# Request for Class II Permissive Change

**FCC ID: VG8XM134AYY**

Please be notified that we, the undersigned, **Guangdong Midea Microwave and Electrical Appliances Manufacturing Co.,Ltd.** declare that the reasons for this class II permissive change are as below:

**Mother board with linear transformer**

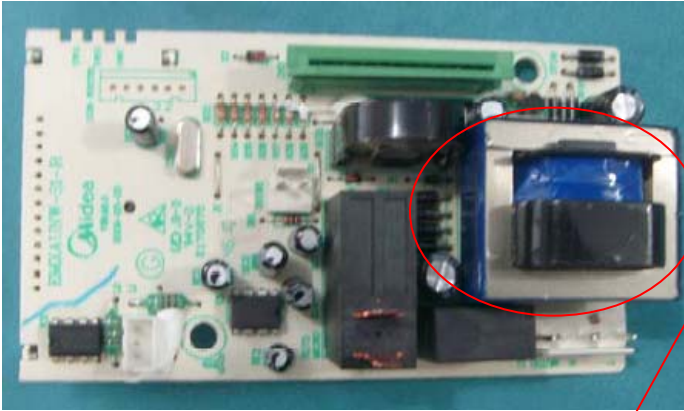
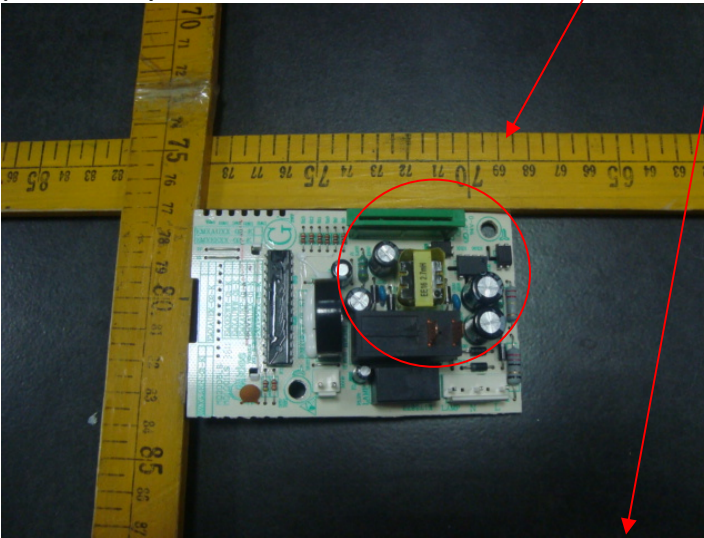
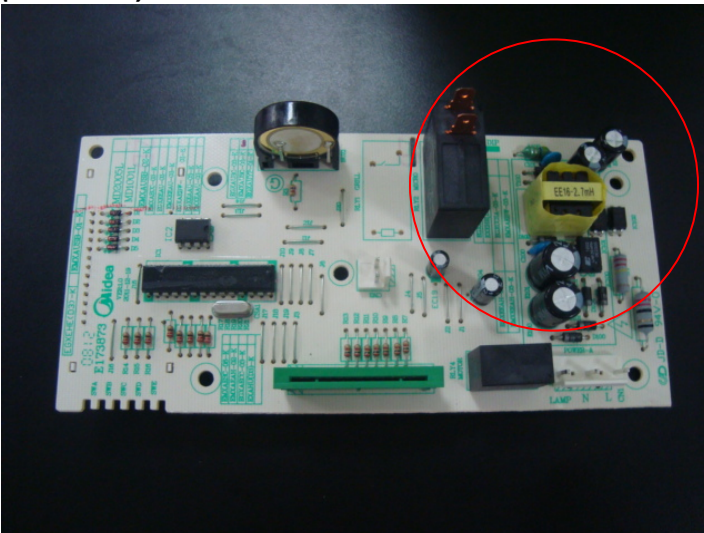
- Updated mother board as below:

Changed linear transformer to the following two switching power supply(MD1001LSB and MD1001LB).

1. Two switching power supply have the same electric specification & circuit function, only PCB layout and component's location are different.

2. Between linear transmitter and switching power supply have the same specifications of rated output power, Changed to the switching power supply, rated output power have not obvious changes.

3. Mother board MD1001LSB was selected for the final testing.
